Access Compliance Report

Public Rights-of-Way

Intersection ID: 49928	Main Street: PAXTON_RUN_RD	Cross Street: CAMPBELL_HALL_CT	Location: SE
ADA ID: 15CDC9AE1998	Ramp Type: BlendTrans1	Initial Pass/Fail: Pass	Overall Compliance: No
Severity Score: 5			
Codes/Mitigation Info/Possible Solution		Field Measurements/Component Compliance

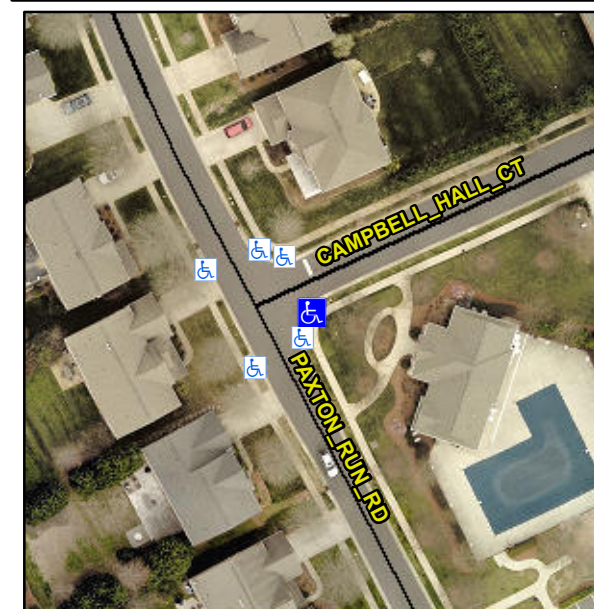
Remove & Replace Curb Ramp With Two New Directional Ramps or Equivalent. Remove & Replace Gutter.

Not Found, R304.2.2-Perp, R304.3.2-Para, R304.5.4
